ST MARYS FREIGHT HUB

RESPONSE TO SUBMISSIONS

PREPARED FOR:
PACIFIC NATIONAL

OCTOBER 2019

FIGURE 11 UPDATED – OVERALL LAYOUT PLAN

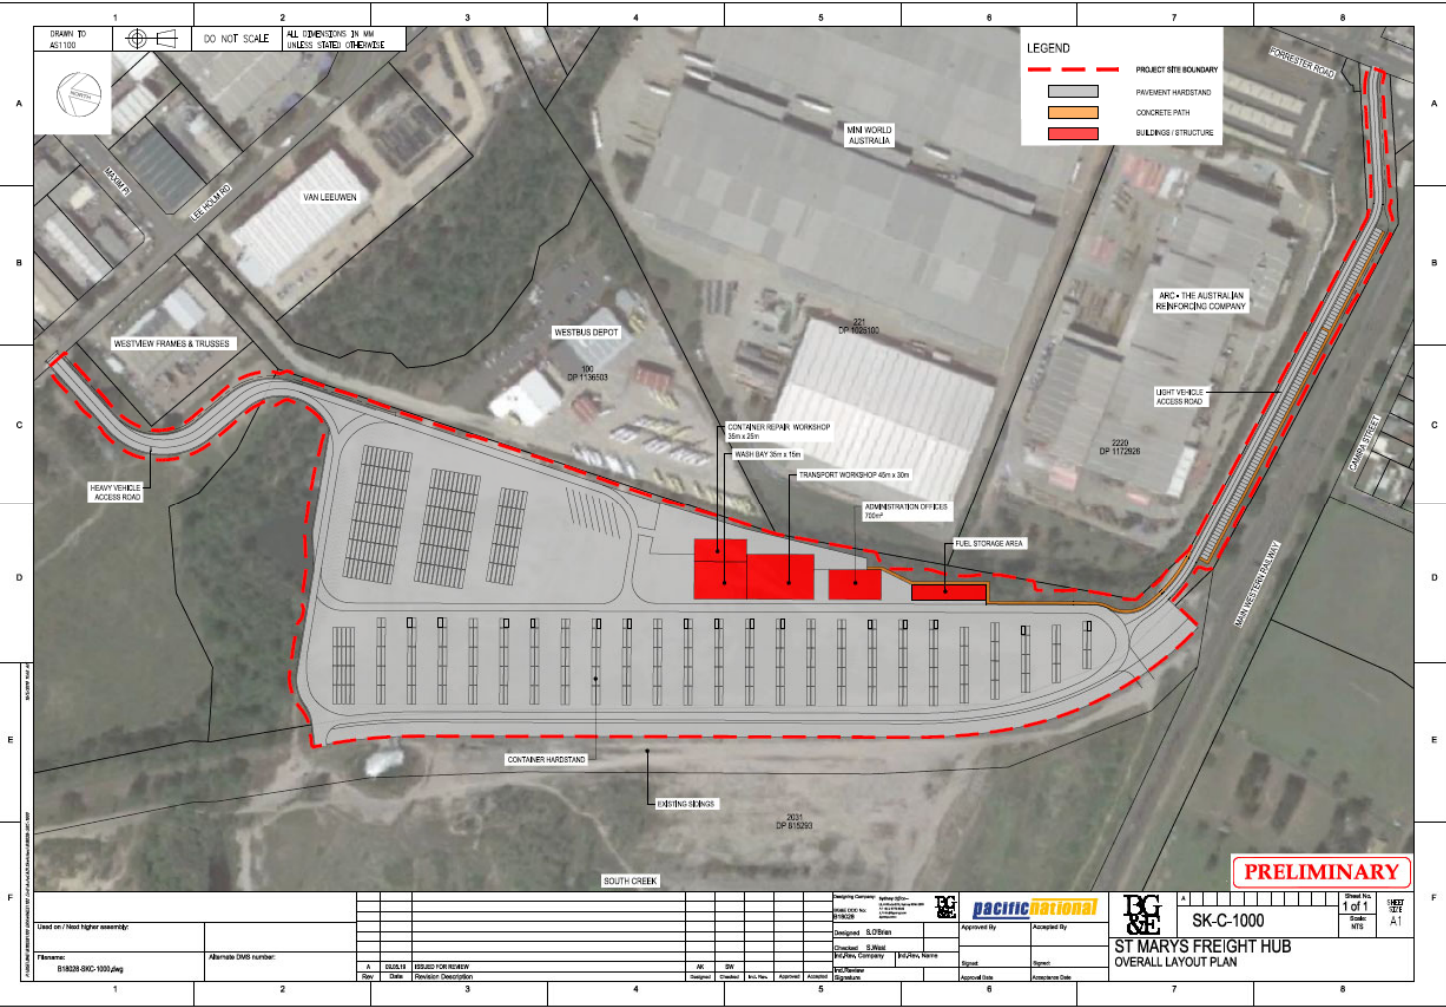
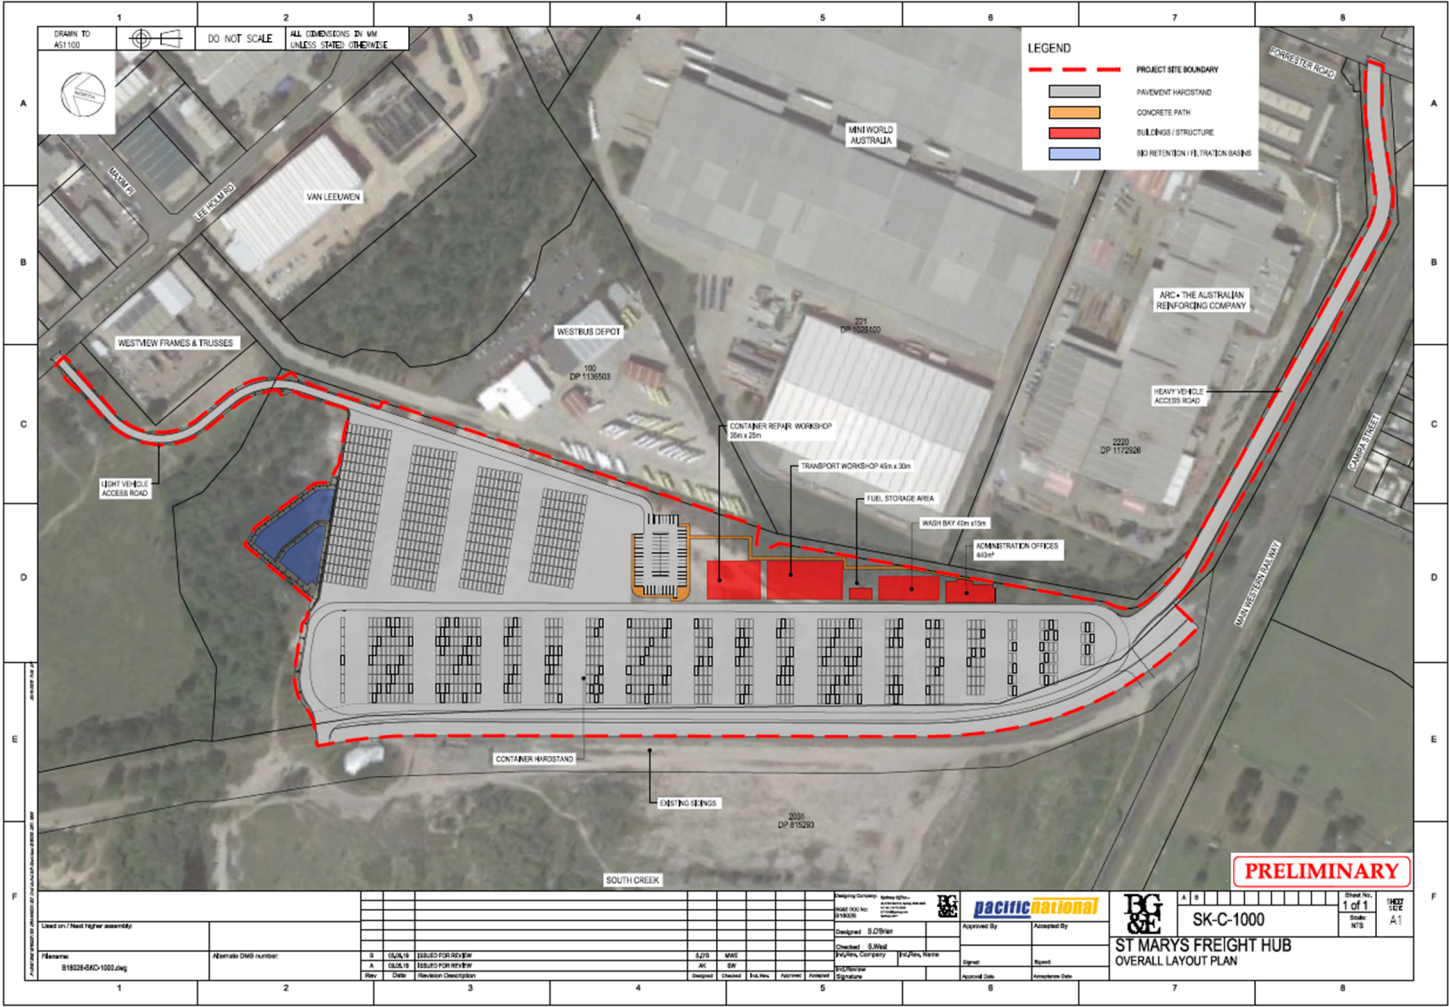
ELEMENT	EXHIBITED SITE LAYOUT	MODIFIED SITE LAYOUT
Area of development footprint	9.6ha	9.6ha
Light vehicle access	From Forrester Road	From Lee Holm Road
Heavy vehicle access	From Lee Holm Road	From Forrester Road
Internal access road from Forrester Road		Area and width increased to accommodate heavy vehicle widths, turning movements and waiting bays at site exit
Internal access road from Lee Holm Road		Area and width reduced, resulting in reduced impacts on vegetation and Little Creek and a smaller development area
Internal access roads		Reduced operational area dedicated to internal vehicle access roads
Staff and visitor car parking	Located within the access leg to/from Forrester Road, parallel to rail line	Co-located with operational and administrative buildings
Bio retention filtration basin		Included, resulting in an increased development area
Fuel storage		Relocated north to abut operational buildings

Administrative building		Relocated south, away from operational buildings
Truck parking	Dedicated truck parking bays	Allowance for dedicated truck parking bays
Pedestrian and cyclist access	Allowance for pedestrian and cyclist access from Forrester Road entry	Allowance for pedestrian and cyclist access from Lee Holm Road and Forrester Road entry

FIGURE 13 UPDATED – CONSTRUCTION STAGING PLAN - STAGE 1

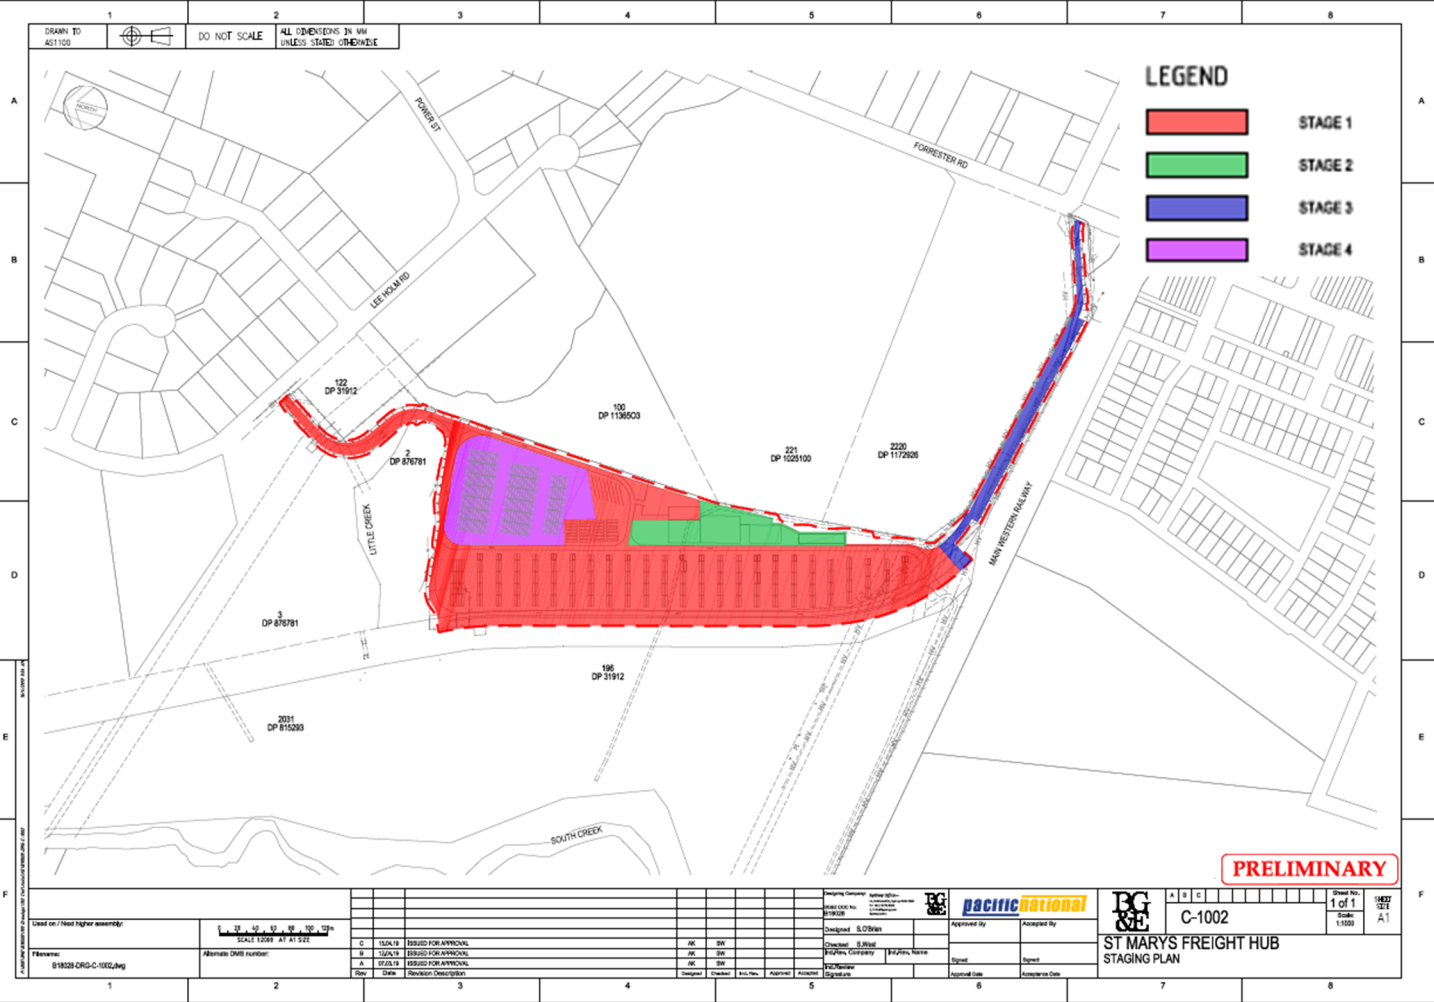
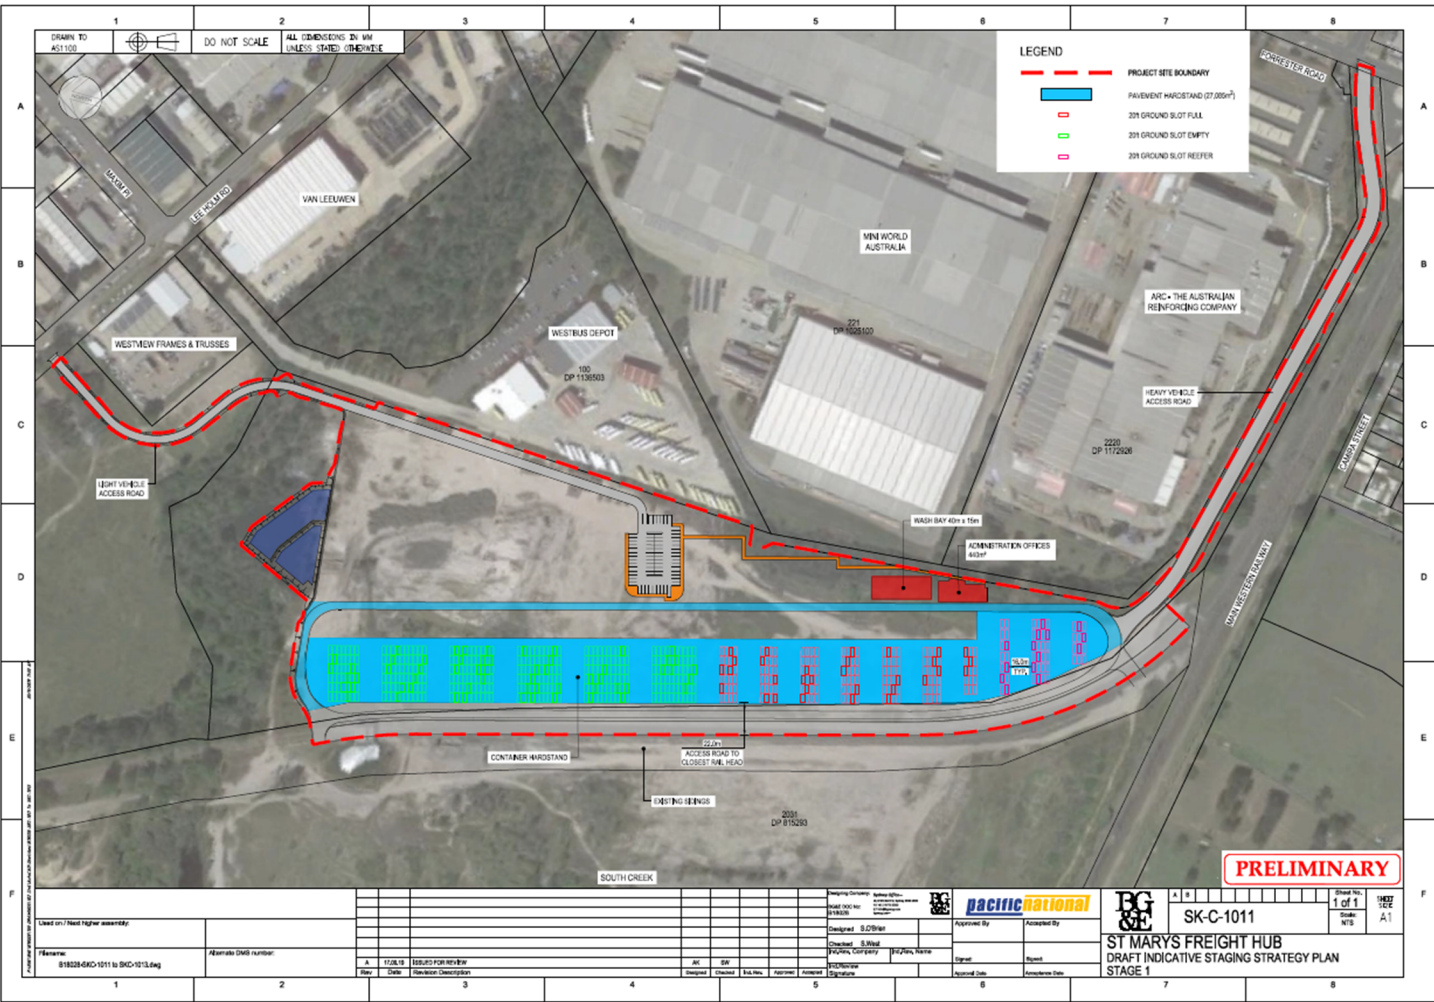
Figures 12 - 15 below, illustrate the proposed staging at the time of exhibition and the updated staging plan. Refer to Appendix 2.

FIGURE 16 UPDATED – LOCATION OF PROPOSED ACOUSTIC FENCE

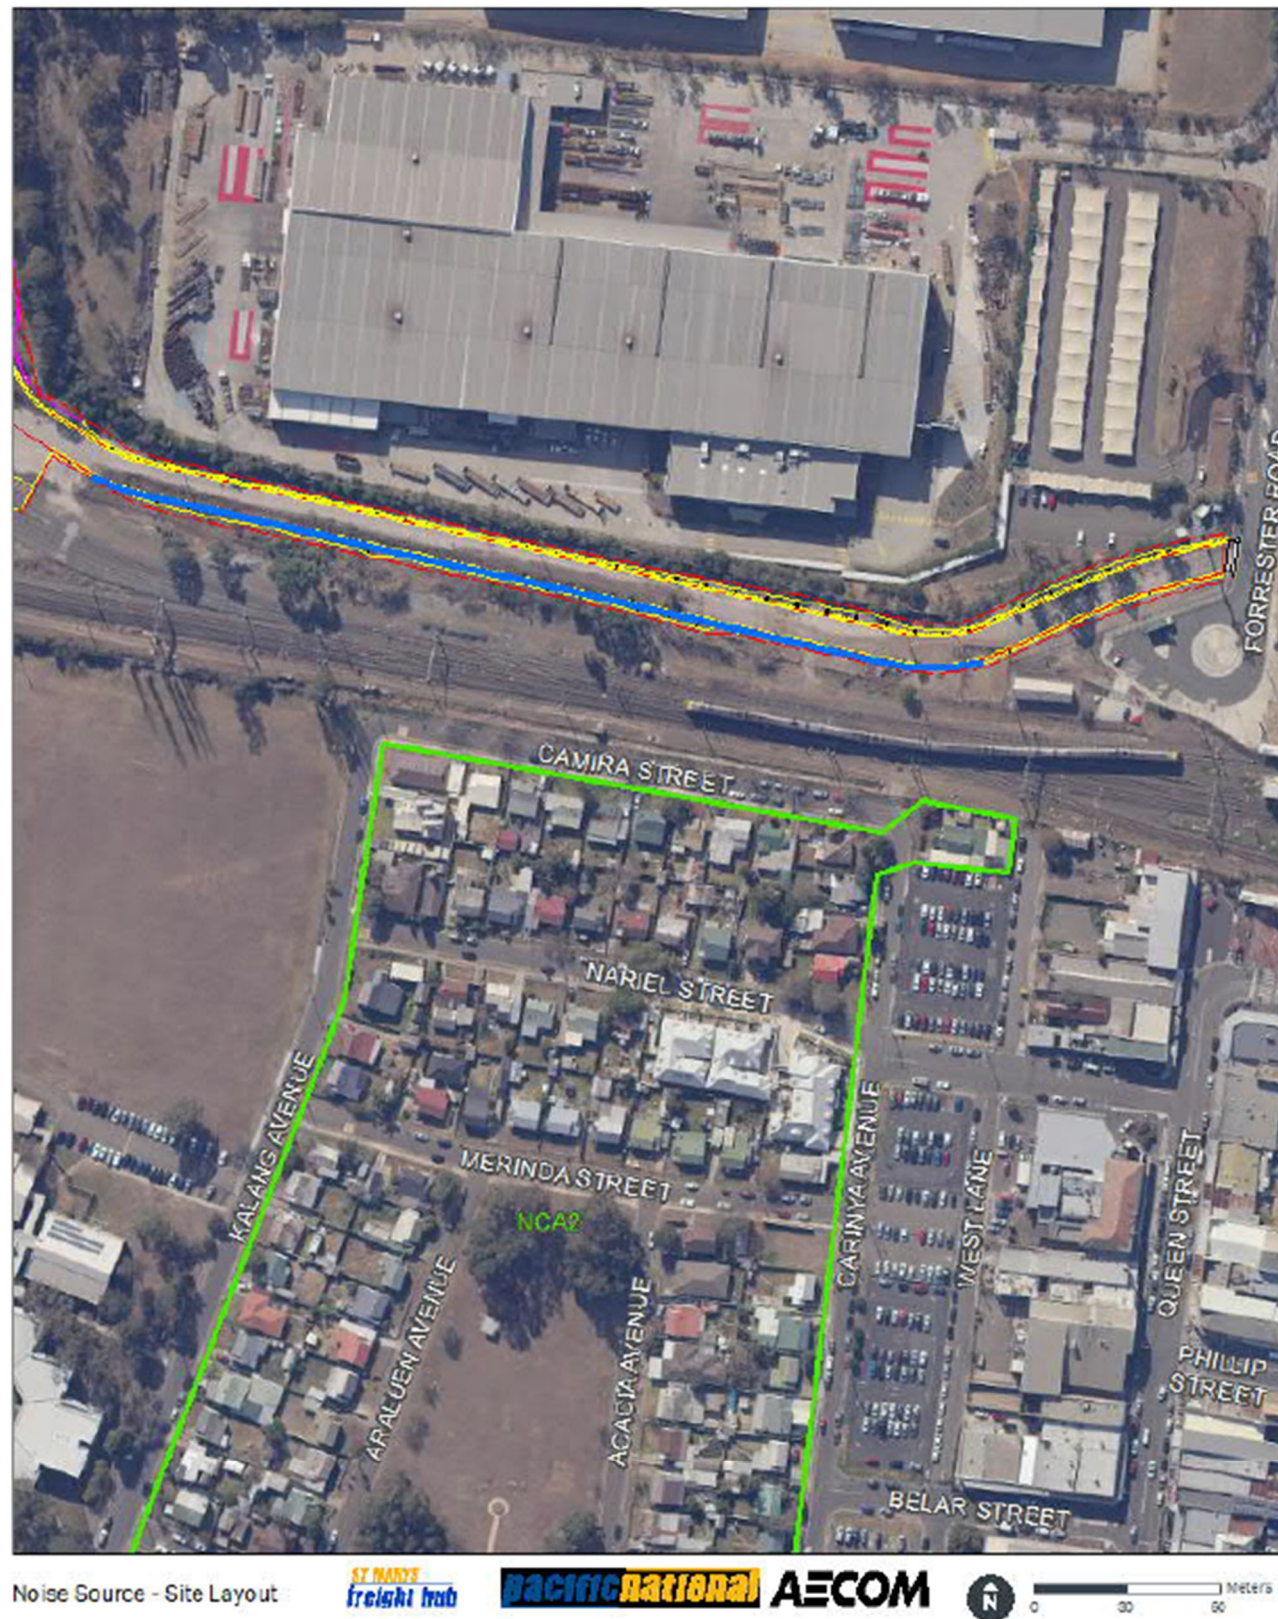
Figure 16 below, from the updated Noise and Vibration Impact Assessment, illustrates the recommendation to construct acoustic fence 2.4 metres in height along the southern boundary of the internal access leg to Forrester Road, as shown by the blue line. Refer to Appendix 5 – Noise and Vibration Impact Assessment.

FIGURE 18 UPDATED – AFFECTED PROPERTIES BY OPERATIONAL NOISE IMPACT

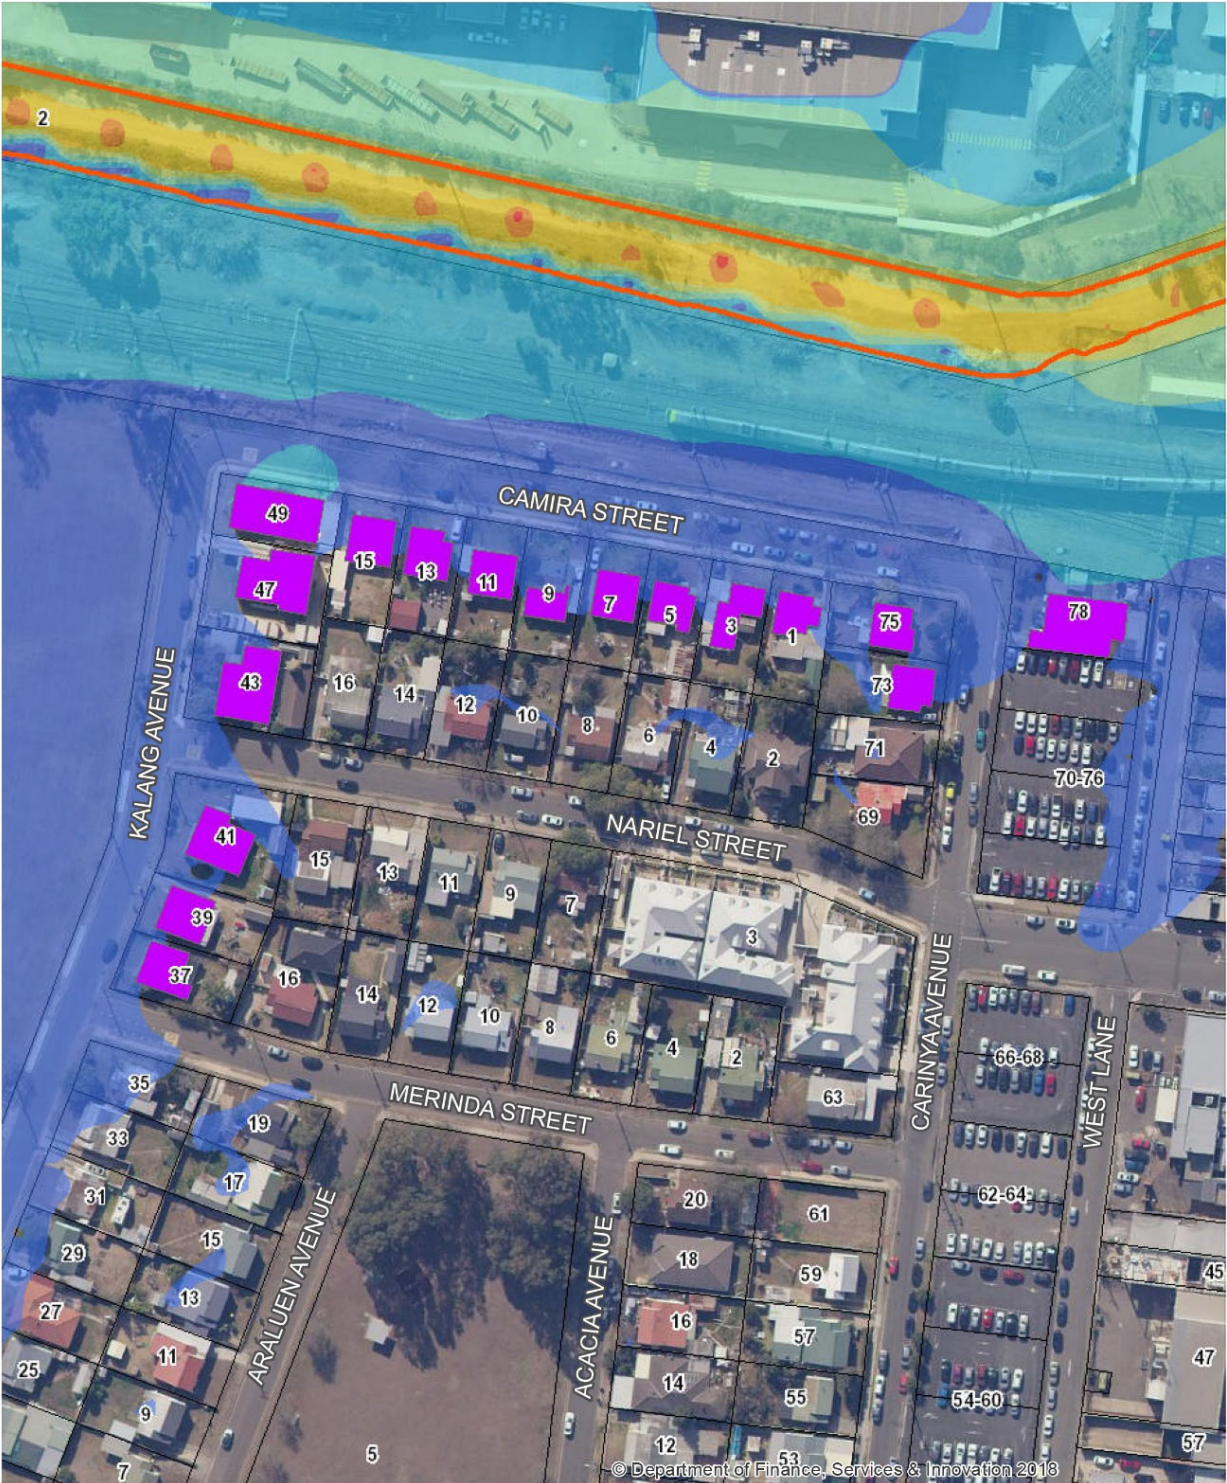
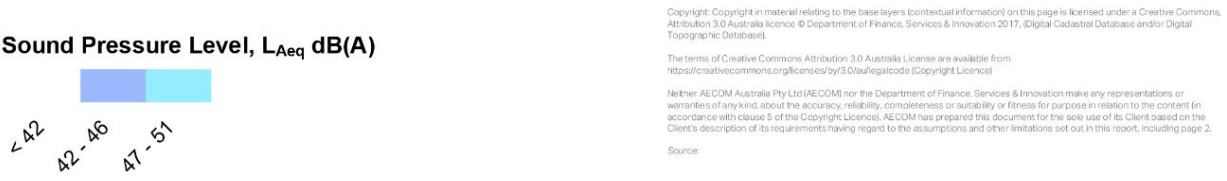
Figures 17 and 18 below, from the updated Noise and Vibration Impact Assessment, illustrates the properties recommended for at-property treatments. Refer to Appendix 5 – Noise and Vibration Impact Assessment.
